Access Compliance Report Public Rights-of-Way (Curb Ramps)

Main Street: THOMAS_DR Cross Street: PACIFIC_AVE Location: NE

ADA ID: RPRK210922124128 Ramp Type: Type 1 - Perpendicular Diagonal Initial Pass/Fail: Pass Overall Compliance: No Severity Score: 25

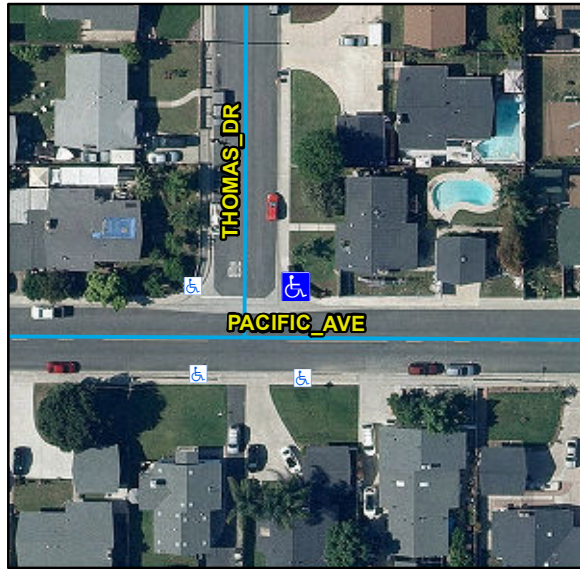
Compliance	Description	Data	Compliance	Description	Data
N/A	Ramp Length (in)	50	N/A	Flare Type LT	
Yes	Ramp Width (in)	48			Sloped
Yes	Ramp Run Slope (%)	4.3	No	Flare Slope LT (%)	12.2
Yes	Ramp Cross Slope (%)	0.6	N/A	Flare Traversable LT	Yes
N/A	Landing Present	No	N/A	Flare Type RT	
N/A	Landing Length (in)	N/A			Sloped
No	Landing Width (in)	N/A	No	Flare Slope RT (%)	11.8
No	Landing Run Slope (%)	N/A	N/A	Flare Traversable RT	Yes
No	Landing Cross Slope (%)	N/A	No	DWS Provided	No
N/A	Landing Movement Obstructed?	Yes	N/A	DWS Contrast	N/A
	Landing Movement Type	Bushes	N/A	DWS Length (in)	N/A
N/A	Landing Shared	N/A	N/A	DWS Full Width	N/A
N/A	Clear Space	Yes	N/A	DWS Offset Left (in)	N/A
N/A	Clear Space To Crosswalk (in)	48	N/A	DWS Offset Right (in)	N/A
N/A	Marked Crosswalk 1	No	N/A	Marked Crosswalk 2	No
	Crossing 1 Direction	W		Crossing 2 Direction	S
	Marked Crosswalk 1 Width (in)	N/A		Marked Crosswalk 2 Width (in)	N/A

N/A	Ramp Inside Crosswalk 1	N/A	Yes	Ramp Inside Crosswalk 2	N/A
	Crossing 1 Slope (%)	1.9		Crossing 2 Slope (%)	0.1
	Crossing 1 Cross Slope (%)	3.5		Crossing 2 Cross Slope (%)	4
Yes	Gutter Ponding	No	Yes	Curb Slope	4.1
Yes	Gutter Lip Height (in)	0		Road Run Slope (%)	0.8
Yes	Gutter Run Slope (%)	0.1		Road Cross Slope (%)	0.5
Yes	Gutter Cross Slope (%)	0.6			
Yes	Overall Surface Condition: Acceptable		Yes	Perp Joint Present	Yes
	Cross Gutter Present?	Yes		Spandrel Present?	Yes
	Replace Cross Gutter?	No		Replace Spandrel?	No

Remove & Replace Curb Ramp With Two New Directional Ramps or Equivalent.
